Memo

To: Josh Mihaly
From: Jeff Walton, Associate Planner; 910-341-3260
CC: File;
Date: 4/29/2016
Re: Sea Sell Auto

Site Plan Comments:

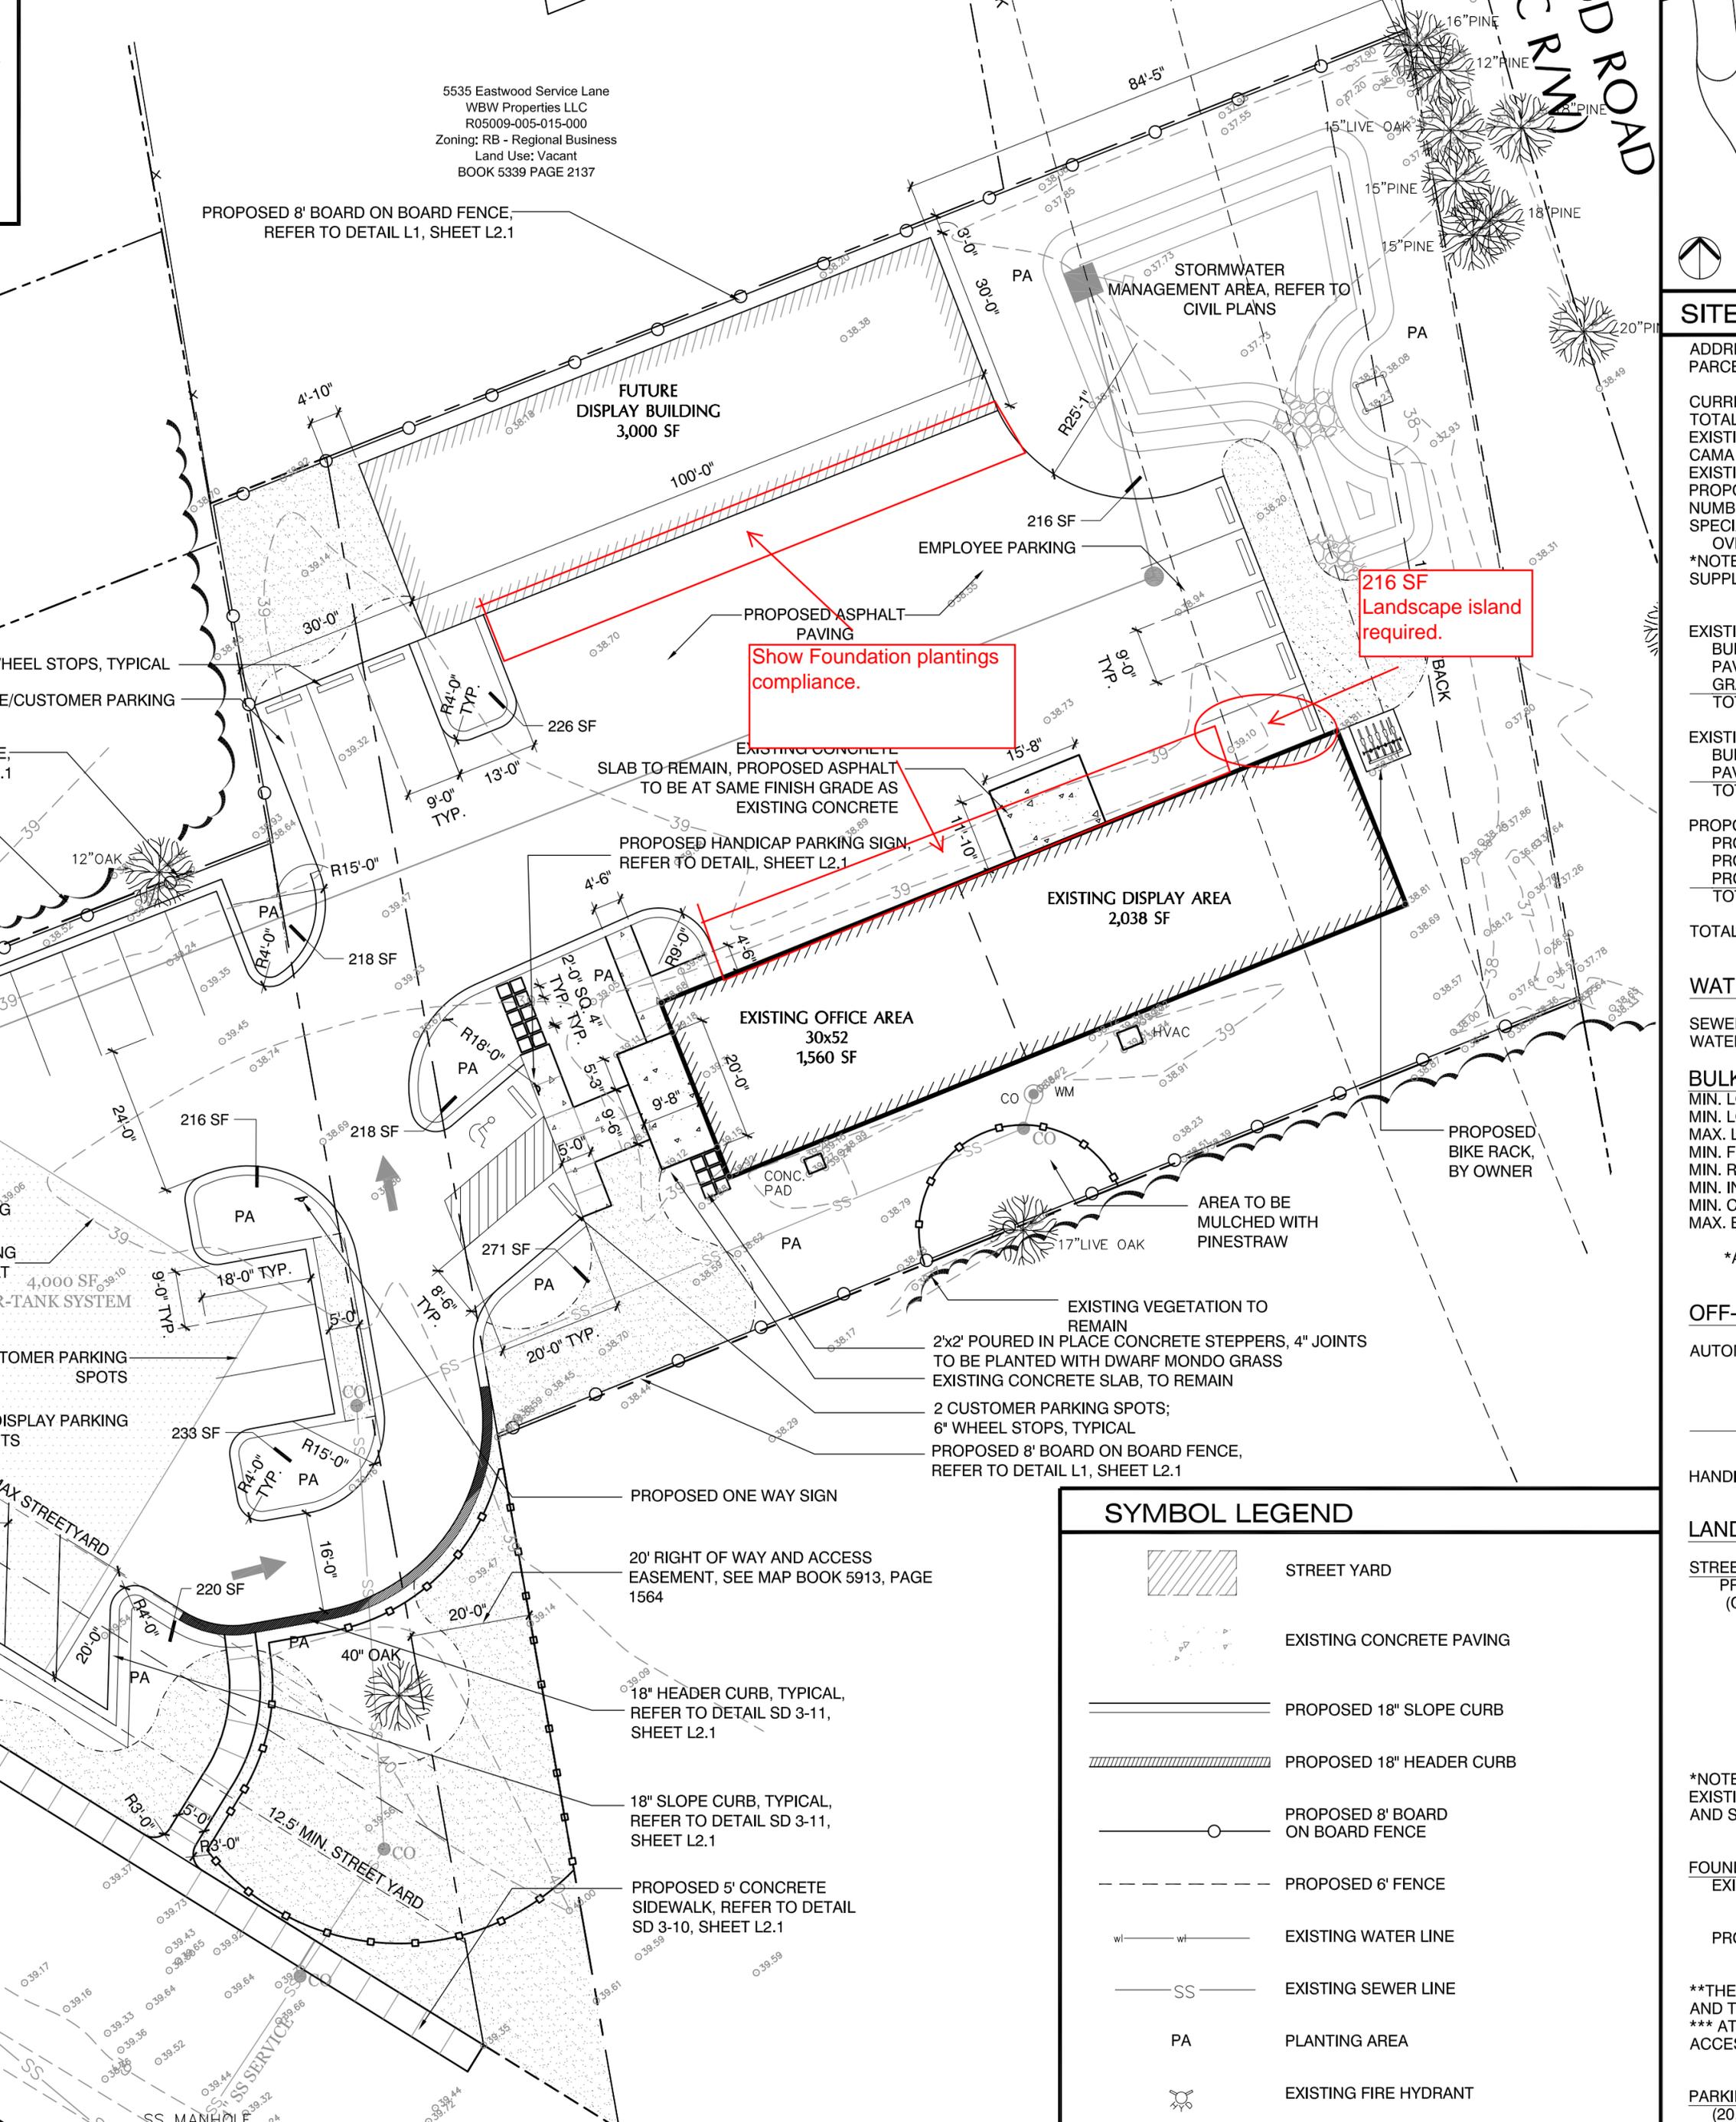
- In the attached redline, you are missing a landscape island. I know we have talked about this island already.

- In the parking lot islands the one closest to the dogwood along the side near the front does not have a label of the proposed tree, bald cypress I assume?
- Show compliance with foundation plantings for both buildings.
 - I keep commenting on this and quoted code on the previous comments. I don't have a way of exempting the foundation plantings for either building. Please show compliance for that wall of the façade.
 - Its helpful to show doors and garages so we can see if there is any dead space for landscaping.

216 SF
 Landscape island
 required.

Show Foundation plantings
 compliance.
